**SUNDRY NOTICES AND REPORTS ON WELLS**

1. oil well ☐ gas well ☒ other ☐  
2. NAME OF OPERATOR  
AMOCO PRODUCTION COMPANY  
3. ADDRESS OF OPERATOR  
501 AIRPORT DRIVE, FARMINGTON, NM 87401  
4. LOCATION OF WELL (REPORT LOCATION CLEARLY. See space 17 below.)  
AT SURFACE: 790' FNL x 790' FEL, Sec. 29,  
AT TOP PROD. INTERVAL: T-31-N, R-5-W  
AT TOTAL DEPTH:

5. LEASE  
SF-079165 SF-078764  
6. IF INDIAN, ALLOTTEE OR TRIBE NAME  
7. UNIT AGREEMENT NAME  
Rosa Unit  
8. FARM OR LEASE NAME  
9. WELL NO.  
64  
10. FIELD OR WILDCAT NAME  
Basin Dakota  
11. SEC., T., R., M., OR BLK. AND SURVEY OR AREA  
NE/4 - NE/4 Section 29  
T-31-N, R-5-W  
12. COUNTY OR PARISH  
Rio Arriba  
13. STATE  
NM  
14. API NO.  
15. ELEVATIONS (SHOW DF, KDB, AND WD)  
6397' GL

**NEW MEXICO OIL CONSERVATION COMMISSION  
WELL LOCATION AND ACREAGE DEDICATION PLAT**

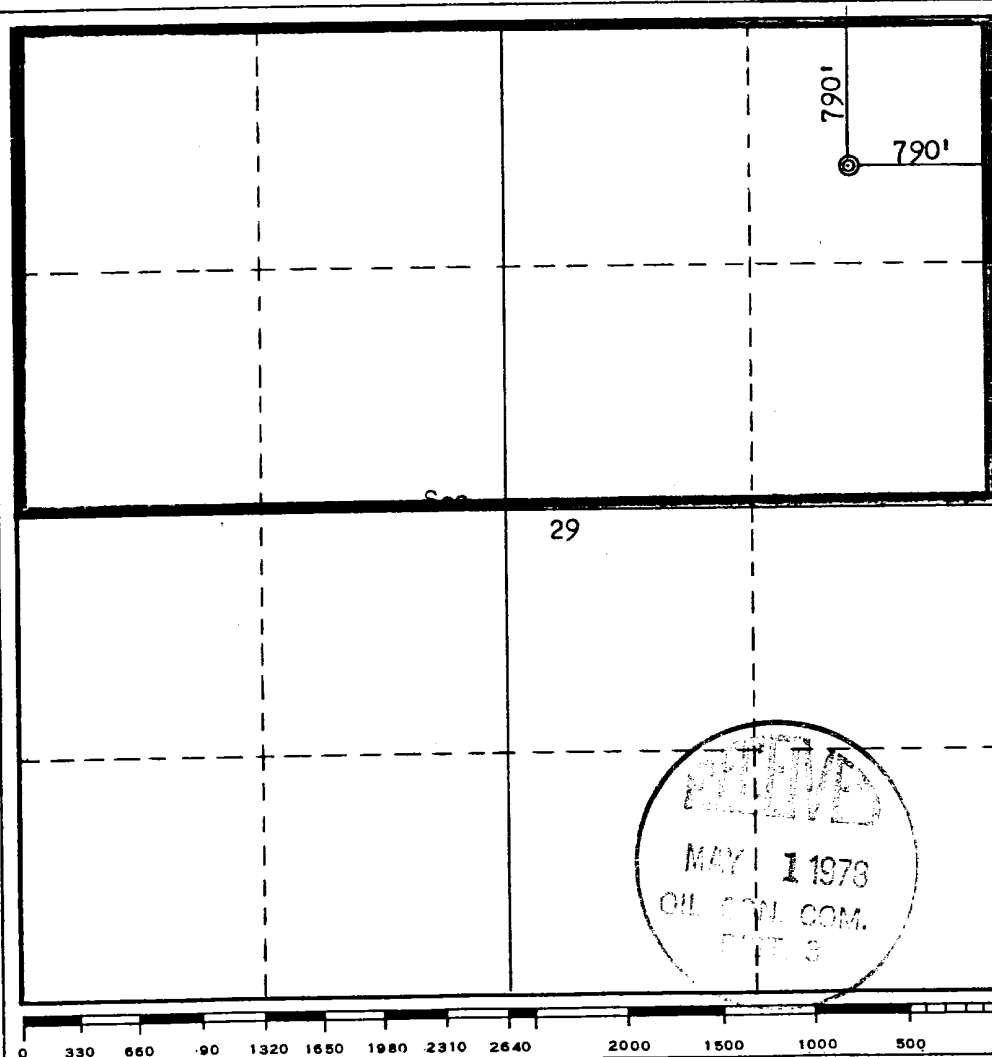
The location for the above well has been re-staked from 1740' FNL x 790' FEL, Section 29, T31N, R-5-W, to 790' FNL x 790' FEL, Sec. 29, T31N, R5W. Attached are revised Survey Plat, Topographic Map showing planned access to new location, and Drill Site Specification Sheet. The only change to our Multi-Point Surface Use Plan is to Item 11, whereby vegetation also includes scattered cedar and pinon trees. The following is our revised casing program:

Operator <b>AMOCO PRODUCTION COMPANY</b>			Lease <b>Rosa Unit</b>		Well No. <b>64</b>
Unit Letter <b>A</b>	Section <b>29</b>	Township <b>31N</b>	Range <b>5W</b>	County <b>Rio Arriba</b>	
Actual Footage Location of Well: <b>790</b> feet from the <b>North</b> line and <b>790</b> feet from the <b>East</b> line					
Ground Level Elev. <b>6397</b>	Producing Formation <b>Dakota</b>	Pool <b>Basin Dakota</b>		Dedicated acreage: <b>320</b> Acres
